The Arcade and 18-20 Corporation Street and 17 Foundry Street, Dewsbury

Summary of Amendments

Doc No. 1705-BDP-AD-XX-RG-Z-00005
Revision: P01
Date: 18 June 2026

DRAWING NO.
1705-BDP-18-ZZ-SE-A-00002-

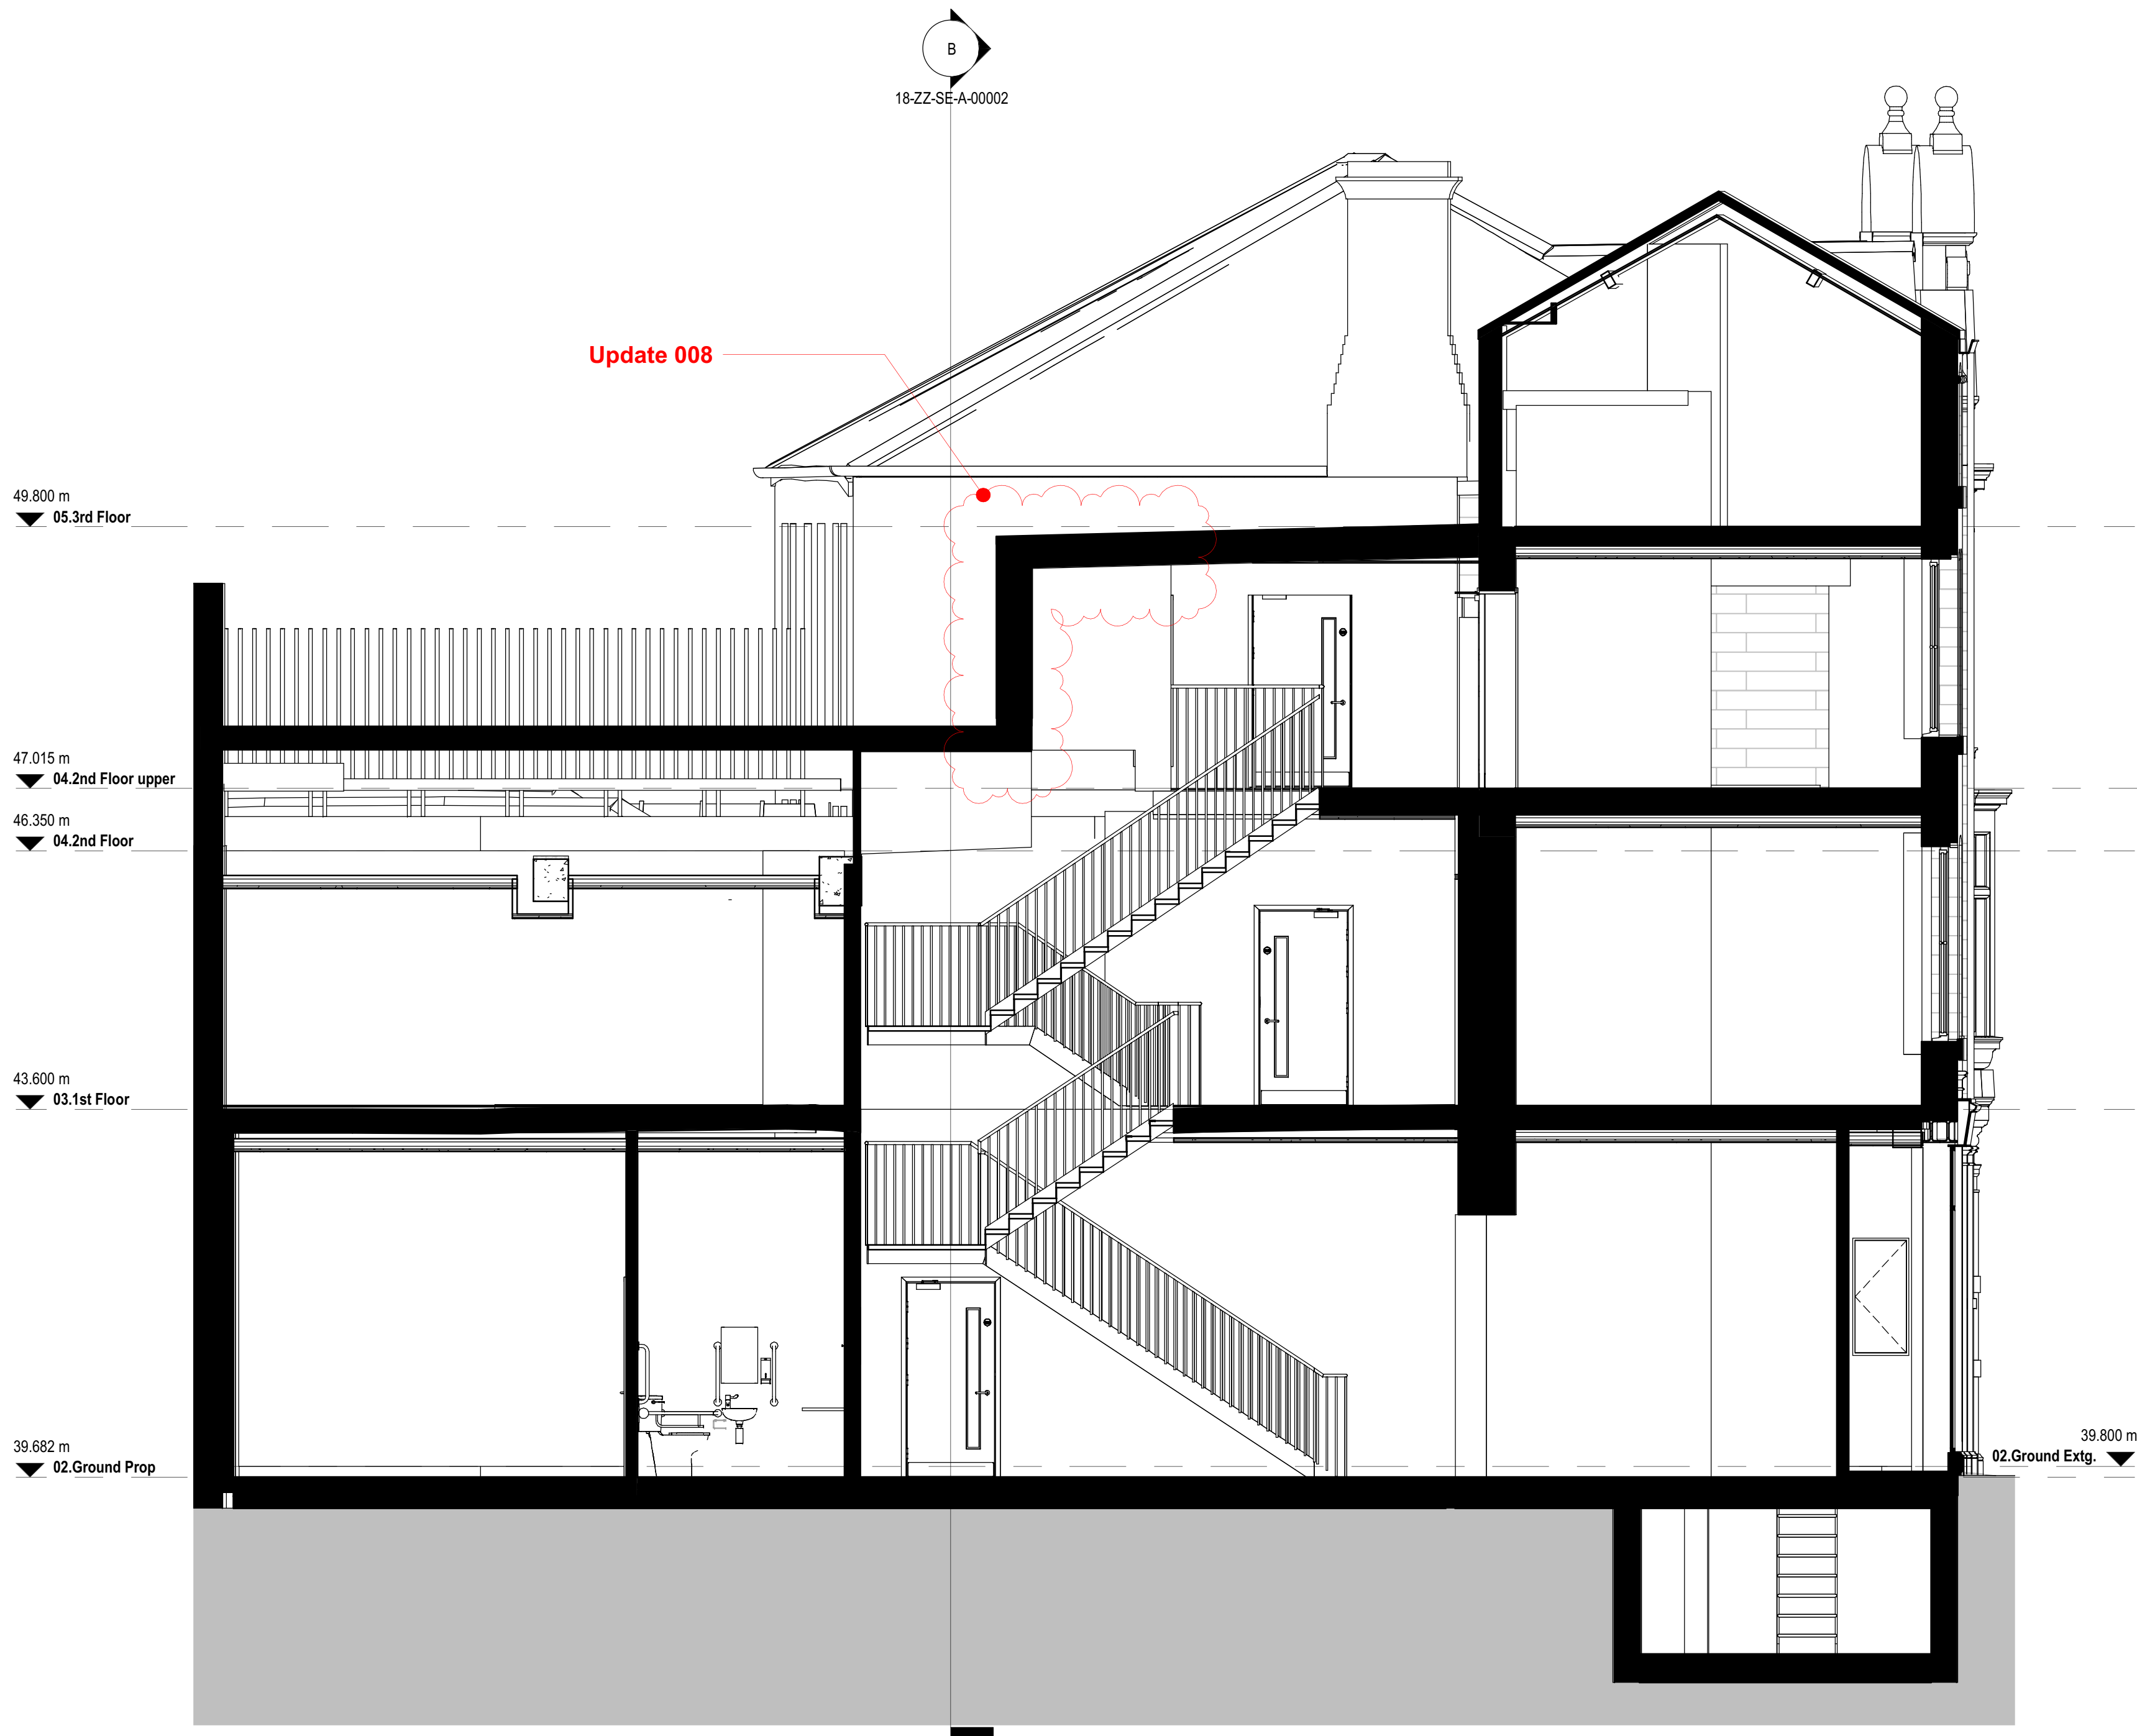
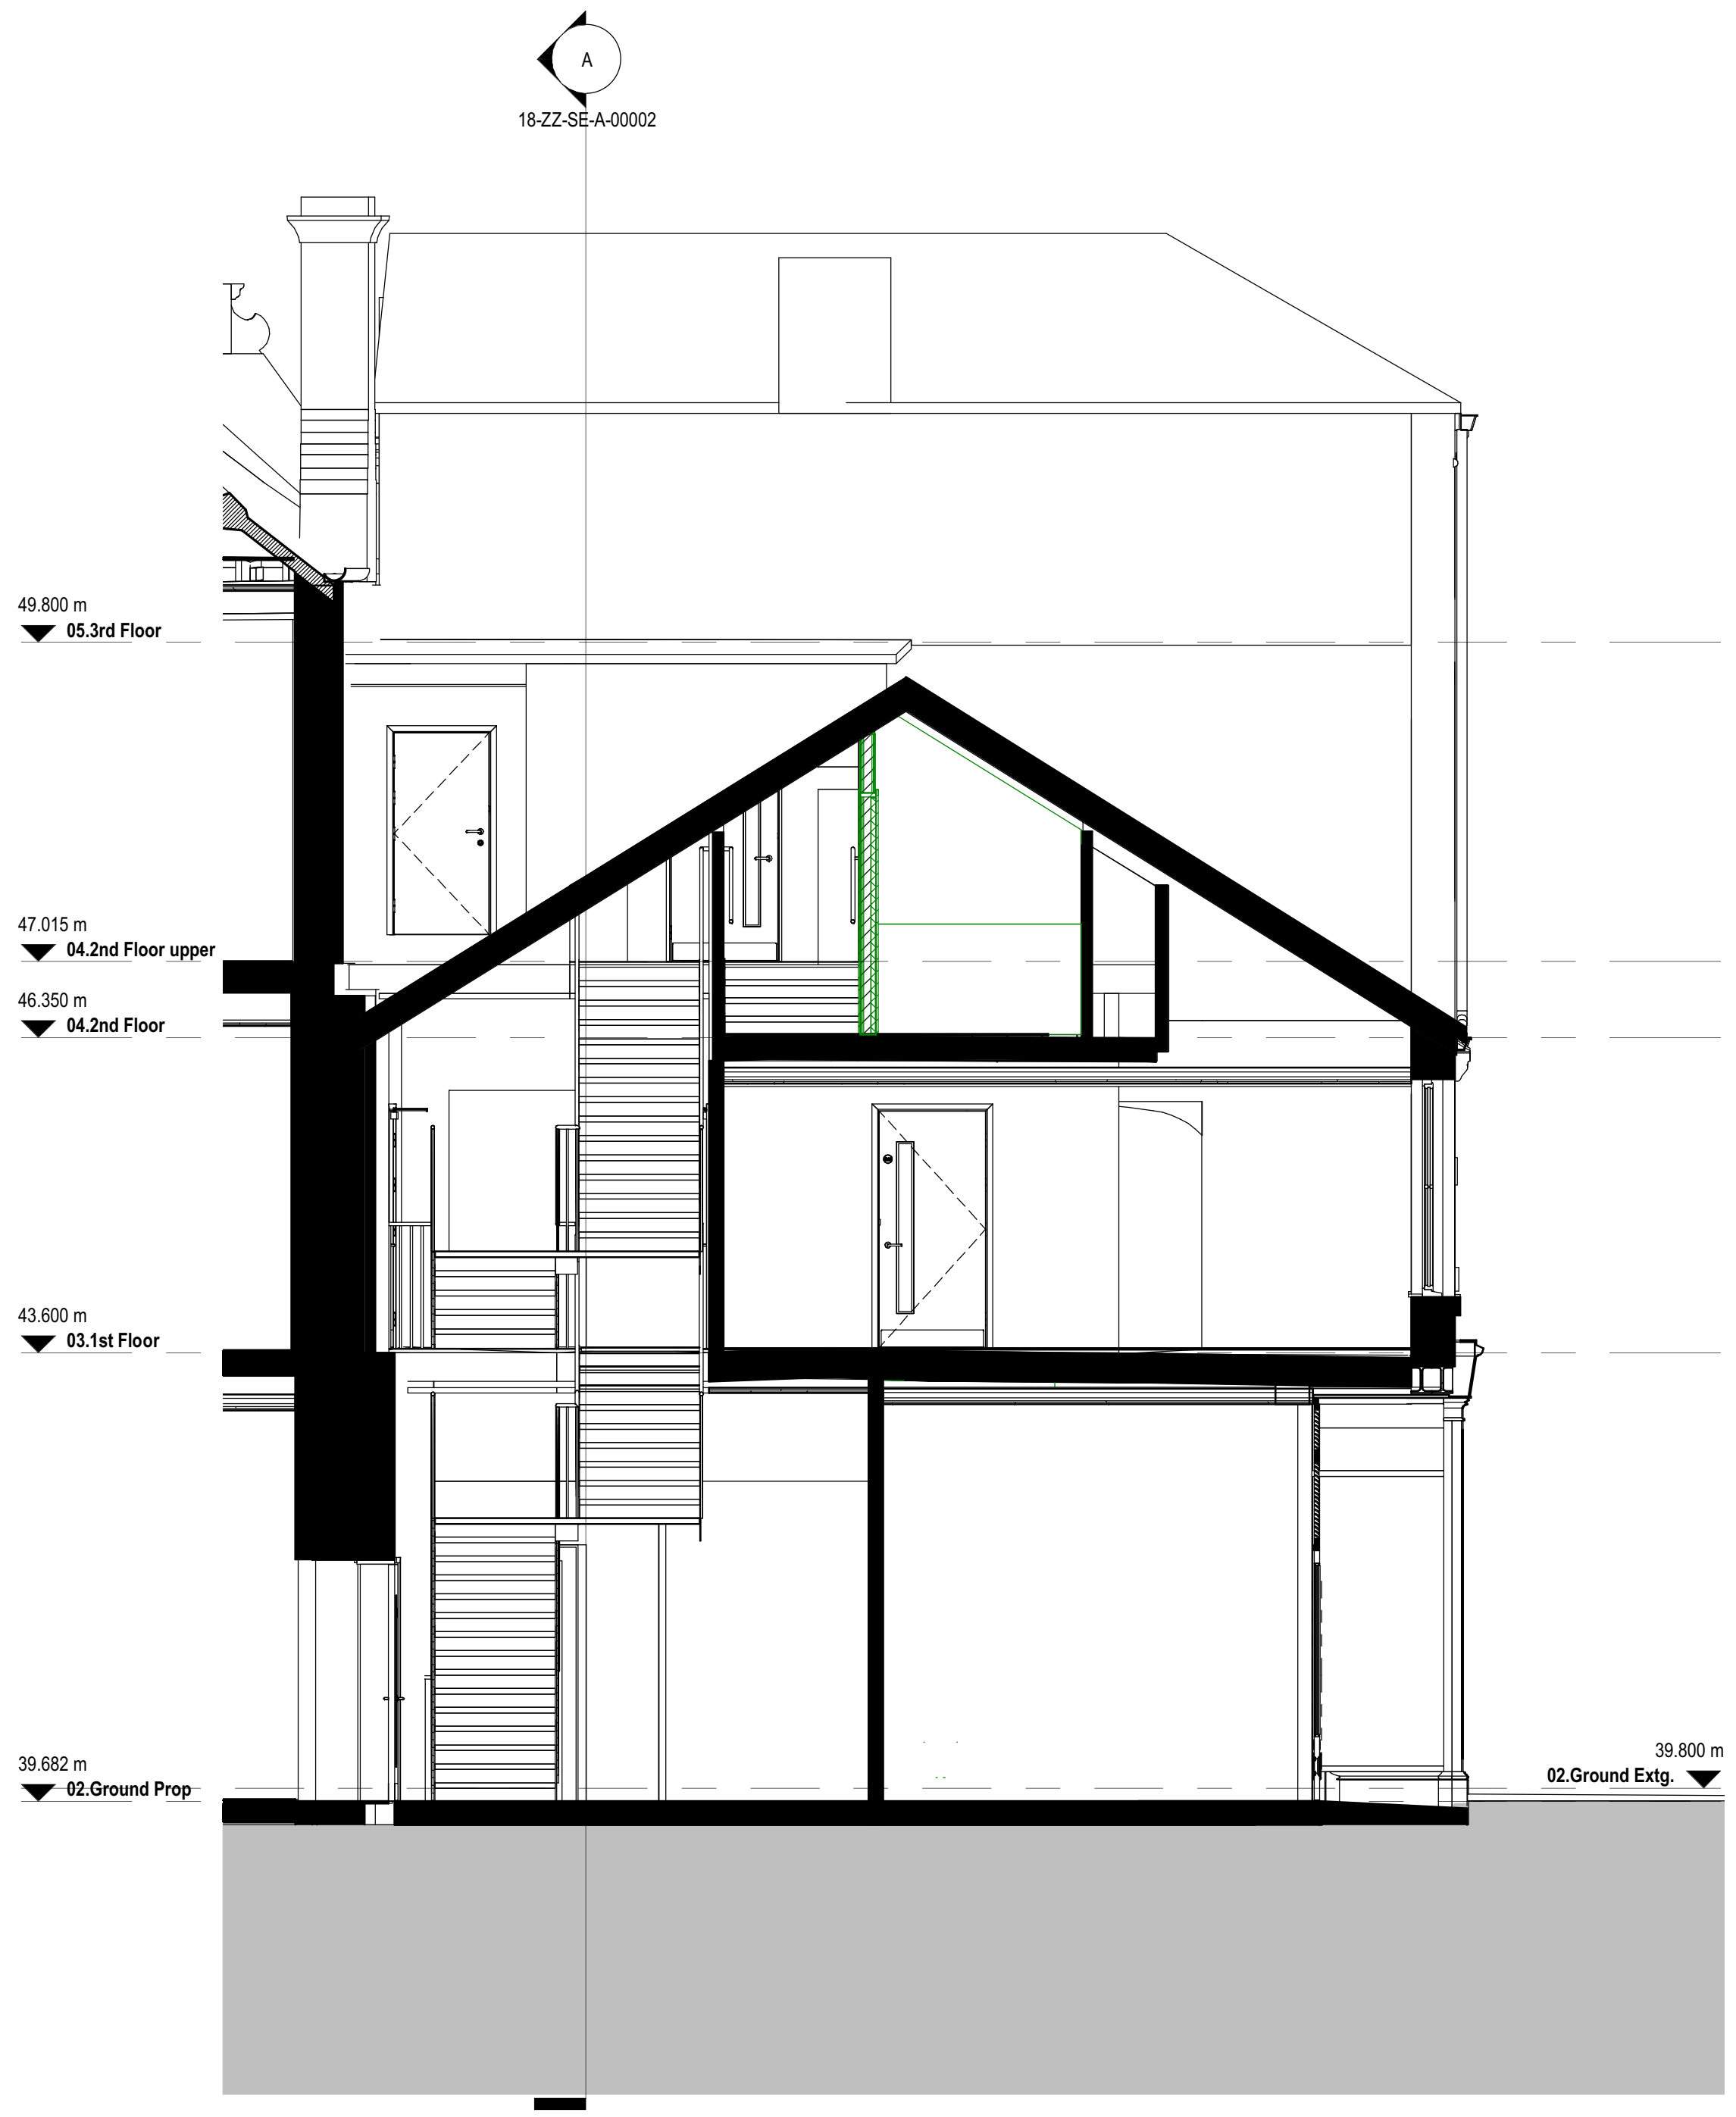
008	17 Foundry Street	Roof	Replace an area of the existing pitched roof (facing away from the principal elevation) with an area of flat roof to provide increased headroom for a new staircase.	The profile of the existing pitched roof and the timber purlins beneath the common rafter extend further into the proposed stair area than previously known.	The extent of the previously proposed roof would not provide sufficient headroom at the head of the new stair.	Slightly increase the extent of this area of flat roof. Note that this will still remain entirely at the rear of the building so will not affect the roof slope on the principal elevation to Foundry Street.	1705-BDP-AD-02-PL-A-20001_T01 1705-BDP-AD-03-PL-A-20001_T01 1705-BDP-18-ZZ-PL-A-00002_P06 1705-BDP-18-ZZ-SE-A-00002_P02 1705-BDP-18-SL-PL-A-00003_P02	1705-BDP-AD-02-PL-A-20001_T02 1705-BDP-AD-03-PL-A-20001_T02 1705-BDP-18-ZZ-PL-A-00002_P07 1705-BDP-18-ZZ-SE-A-00002_P03 1705-BDP-18-SL-PL-A-00003_P03
